**IN THE DRAWINGS:**

REMARKS

This Amendment is submitted in response to the Final Rejection dated March 14, 2006. In the Office Action, the Patent Office requires Applicant to provide information under 37 CFR §1.105 which the Patent Office has determined is reasonably necessary to the examination of the application. Additionally, the Patent Office refused to consider an Information Disclosure Statement (hereinafter "the IDS") filed on January 3, 2006 and asserts that the IDS fails to comply with 37 CFR 1.98(a)(2). Further, the Patent Office objected to the drawings under 37 CFR §1.84(p)(5) because the drawings include a reference character not mentioned in the description. Still further, the Patent Office objected to the drawings under 37 CFR §1.83(a) for failing to show every feature of the invention specified in the claims.

FIG. 8

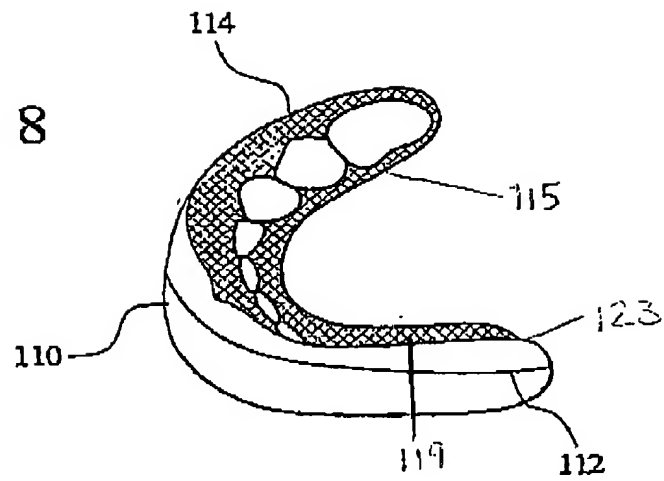
FIG. 8 has been corrected as shown in the Replacement Drawing Sheet and as shown in red in the Annotated Sheet Showing Changes in the attached Appendix.

Further, the Patent Office objected to the drawings under 37 CFR §1.84(p)(5) for failing to include reference signs 115, 117, 119 and 121 which are mentioned in the description. In response to the objection, Applicant amended FIGS. 8 and 9 to show the lingual shields 115, 117 and the buccal shields 119, 121 as set forth on page 22 of the description. Applicant also amended FIGS. 8 and 9 to show the rear portion 123 of the upper shell 110 and the rear portion of the lower shell 120.

The lingual shields 115, 117, the buccal shields 119, 121 and rear portions 123, 125 are disclosed in the specification as filed. Specifically, page 22, lines 2-5 state: "The upper shell 110 and/or the lower shell 120 may have roughened, or coarse surfaces 114, 122, respectively, along the lingual shields 115, 117 and/or buccal shields 119, 121 to secure the reline material 132." Further, page 22, lines 8-10 state: "The lingual shields 115, 117 and the buccal shields 119, 121 may have a mark 112 placed on the roughened surfaces 114, 122." Moreover, page 22, line 35 through page 23, line 2 state: "A rear portion 123, 125 of the upper shell 110 and/or the lower shell 120 may then be forcibly pushed down on the teeth." Applicant submits that the amendment to FIGS. 8 and 9

overcomes the objection by the Patent Office. Notice to that effect is requested.
